Subject: Oconee Nuclear Station  
Docket Nos. 50-269, -270, -287  
Response to Request for Additional Information on  
the Oconee Emergency Power System

REQUEST FOR ADDITIONAL INFORMATION  
OCONEE EMERGENCY ELECTRICAL POWER  
DISTRIBUTION SYSTEM

3LP-17  
ES Test #6  
a phase of current

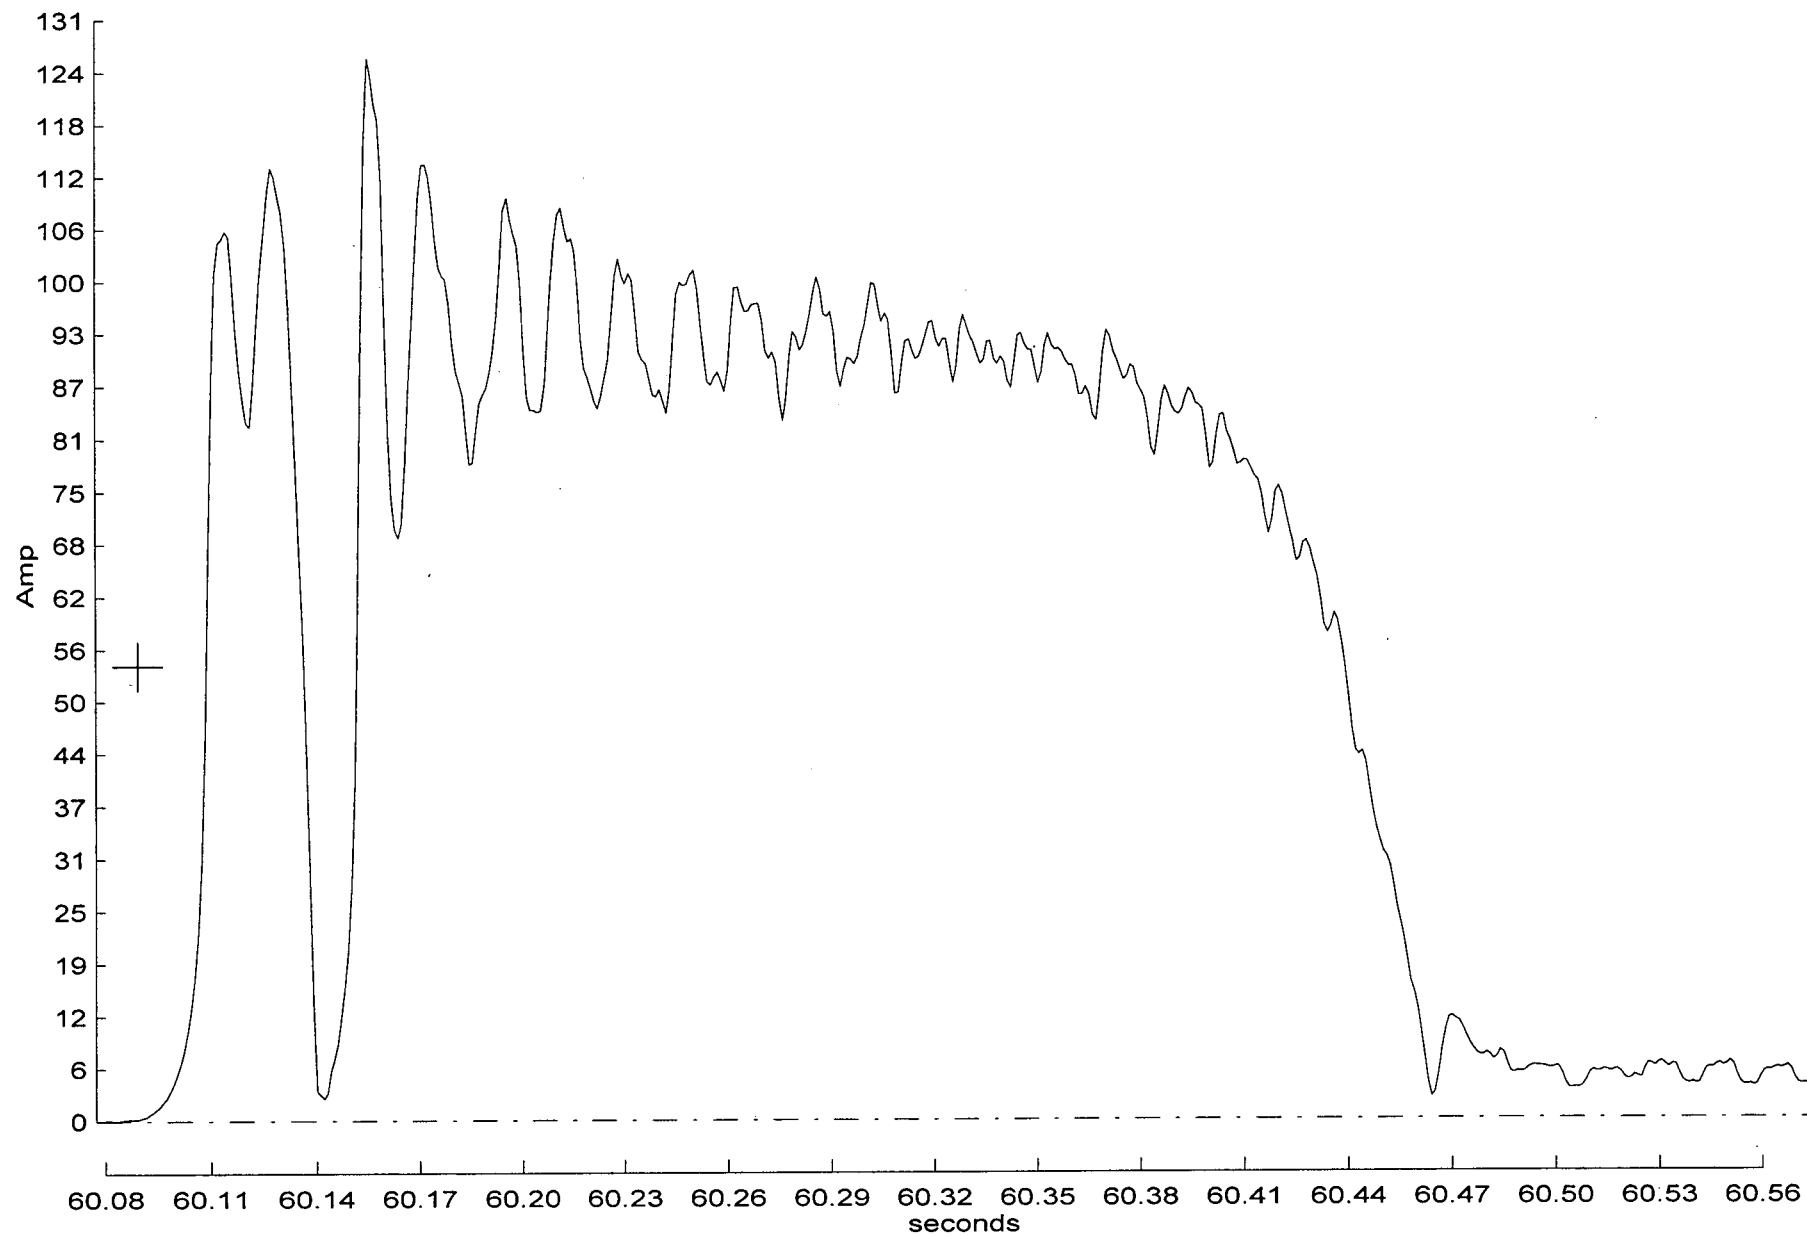
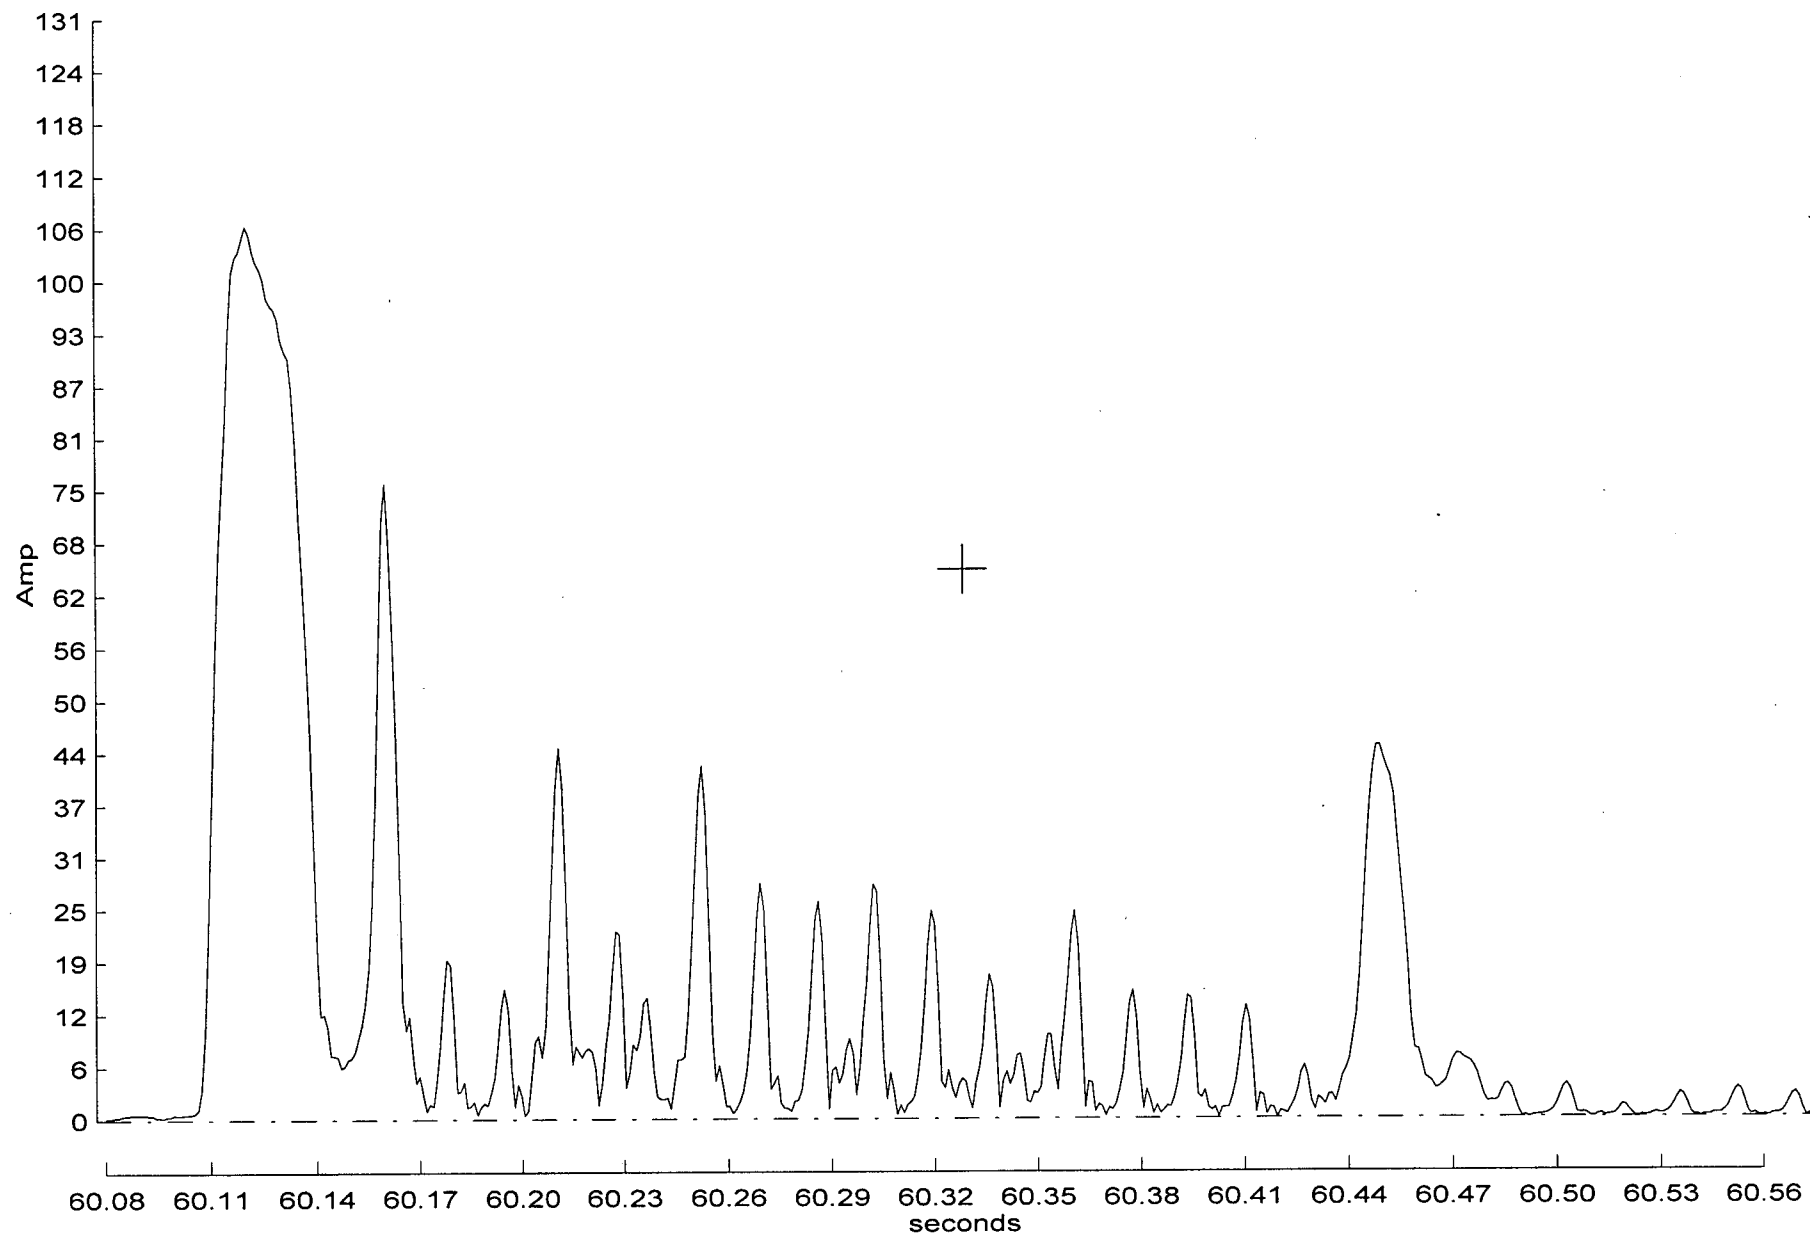
7. Section 5.2.4 of the report states that MOV 3LP-17, which is a gate valve, briefly stalled while starting following contactor pickup during Tests 4, 5, and 6. The stall times were 1.0, 1.0, and 0.4 seconds, respectively, for the three tests. The report indicates that the valve recovered in each case and completed its stroke to its proper ES position; and following inrush, valve stroke was normal and normal hammer-blow and unwedging was observed. We note that in all the LOCA tests where the MOVs are actuated, this particular valve's motor contactor picks up at a voltage value that is quite often one of the largest values seen on the group of valves that are monitored. On that basis, not considering any other variables, it would be expected that this valve would be the least likely to stall.

- d. Please provide plots of the valve motor's thermal capability and overload protection, overlaid on the starting inrush current figures shown for this valve during the tests.

monitored phases was analyzed for inclusion in the report since all valve stroke events could be identified regardless of which phase was analyzed. A more detailed review of the data for all three monitored phases indicates that the primary reason 3LP-17 appeared to stall was that the 'c' phase starter contact chattered while the 'a' and 'b' phase contacts maintained a stable energized state. Therefore, the 'a' and 'b' phases (one of which was included in the report) indicated stall conditions until the 'c' phase contact maintained a stable energized state. Once all three phases were energized, 3LP-17 stroked as expected. In retrospect, 3LP-17 did not actually stall as originally thought. Attachment 6 contains the plots of the current data for 3LP-17 which indicate the chattering of the 'c' phase contact.

Copies of the requested plots are contained in Attachments 2 through 6.

Figure 2-24 - RBCF 3B Voltage and  
Current During Test 5

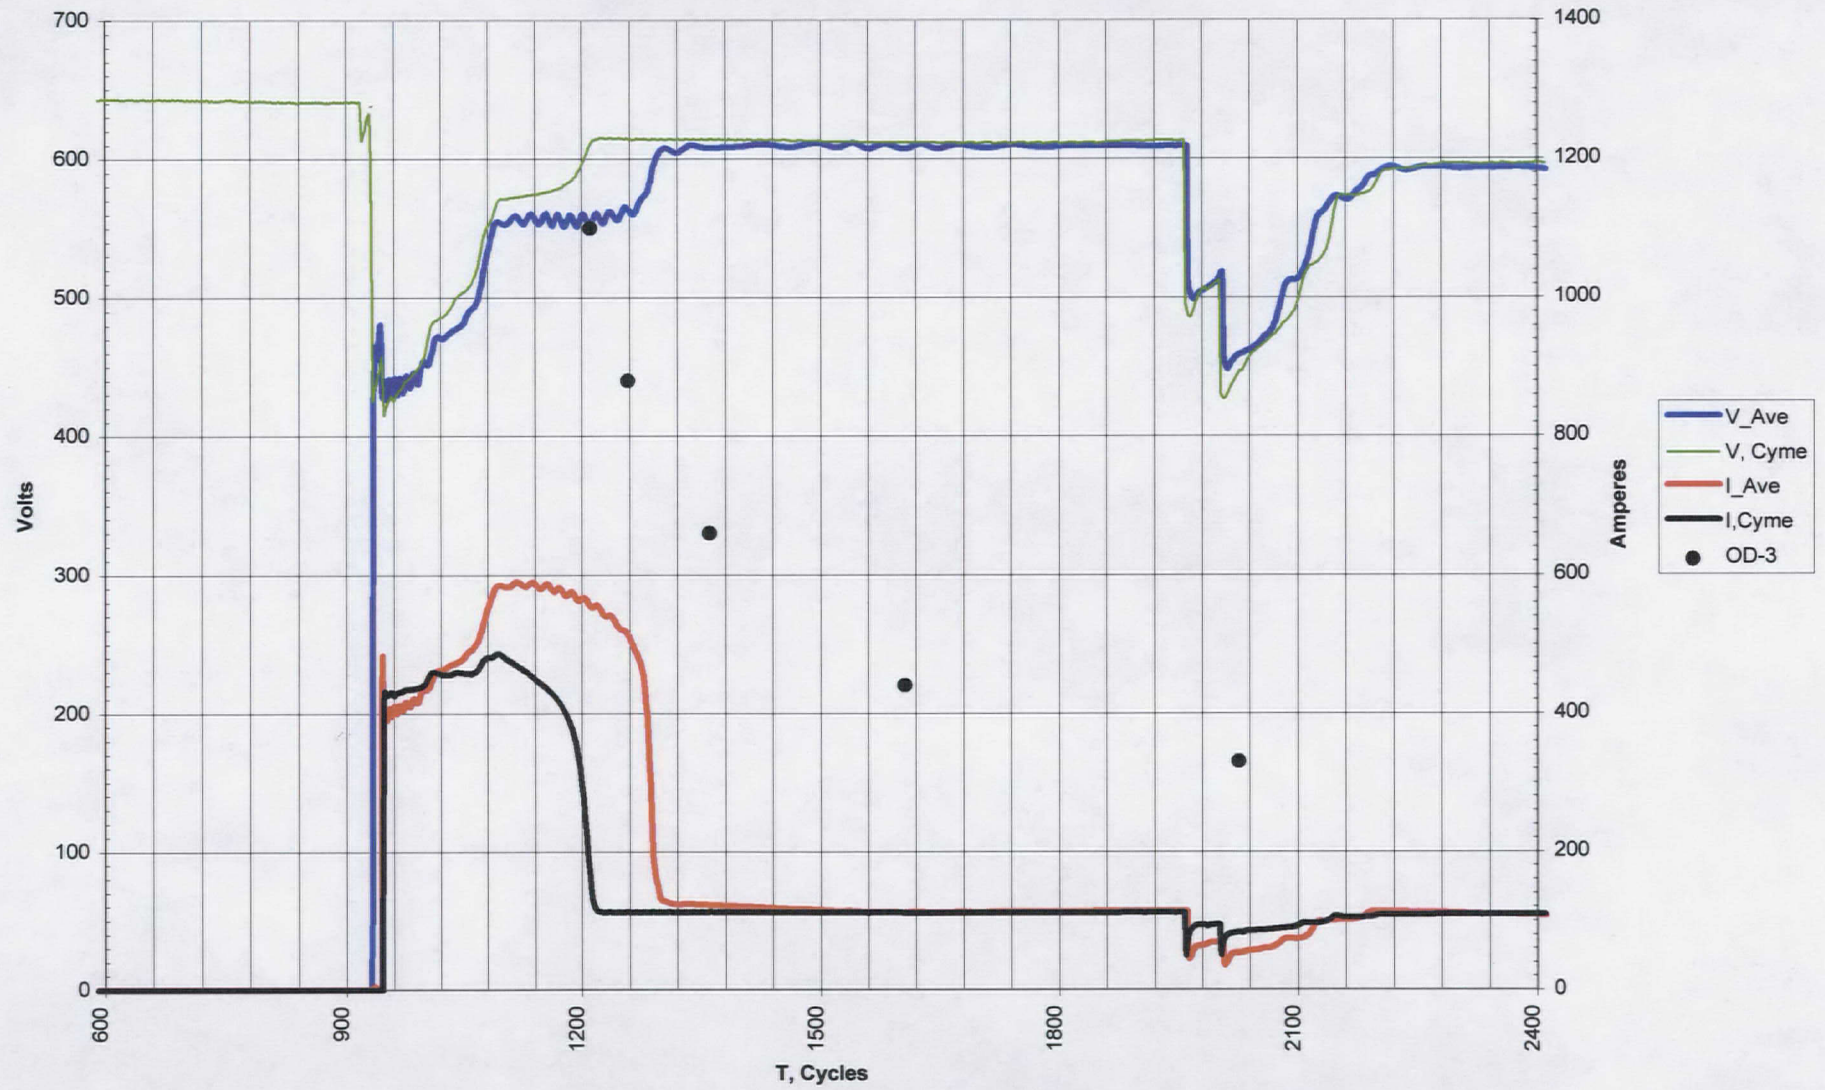
2. In Figure 2-24 of the report, the staff notes that, if the OD-3 trip of the RBCF motor is drawn in as it is in Figure 3-24, the motor starting current is very close to tripping this device. The report attributes the excessively large and long starting current to the reverse rotation of the motor due to damper back leakage, which is scheduled for a modification to better seal the damper.

- a. If the RBCF motor will be rotating backwards prior to an event before the modification is complete, discuss operability of the RBCF in this condition given the very slim margin to motor tripping.

It is important to note that on Figure 2-24, the RBCF motor starts at approximately  $t = 950$  cycles, whereas on Figure 3-24 the RBCF motor starts at approximately  $t = 810$  cycles. The overcurrent device must be plotted based on the time the motor start is initiated. The OD-3 trip device is plotted on the attached copy of Figure 2-24 which is contained in Attachment 7. There is not any substantial difference between the margins shown on Figures 2-24 and 3-24. The fan which was monitored and hence plotted in Figure 3-24, RBCF 3B, is the one expected to have the longest starting time. RBCF 3B is fed from a 300KVA transformer, whereas RBCF 3A and 3C are fed from 1000KVA transformers. Thus, the source impedance for RBCF 3B is higher. The trip device in the circuit to RBCF 3B is the 225A TJJ breaker which when plotted shows significant margin. The OD-3 device is only in the circuits that supply the other two RBCFs (3A and 3C) whose feeder was not directly monitored but are expected to start faster. The starting current for these two fans (along with other loadcenter current) can be seen in Figures 3-32 and 3-34 for Test 6 and Figures 2-34 and 2-36 for Test 5.
